Technical Service Bulletin

MODEL(S) AFFECTED: T16 (Only machines where customer has noted CAN bus failures/error messages)

SUBJECT: Incorrect CAN bus termination resistance possibly causing CAN bus failures/error messages.

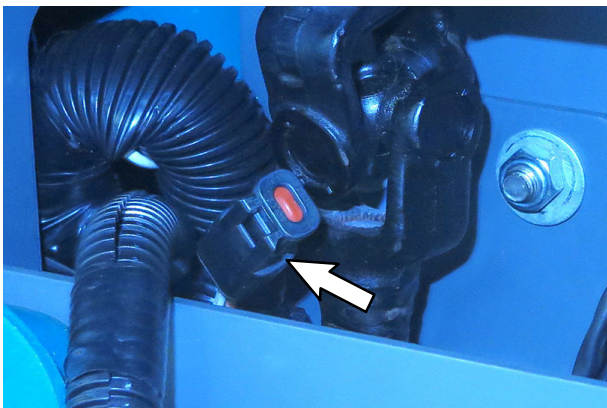
1 Turn key switch OFF.

2. Disconnect battery cable from machine.

WARNING: Always disconnect battery cables from machine before working on electrical components.

3. Remove electrical panel from machine to access portion of main wire harness/terminal resistor located inside steering support channel.

4. Disconnect resistor from main wire harness.

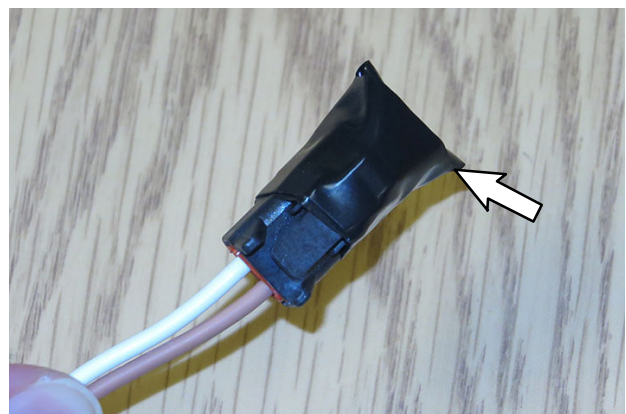
5. Use ohmmeter to test resistance at main wire harness connection where removed resistor was previously located. Should be nominal value of 60Ω.

If less than 60Ω, do not reinstall resistor, tape connector end with electrical tape so connection is completely covered. Discard removed resistor.
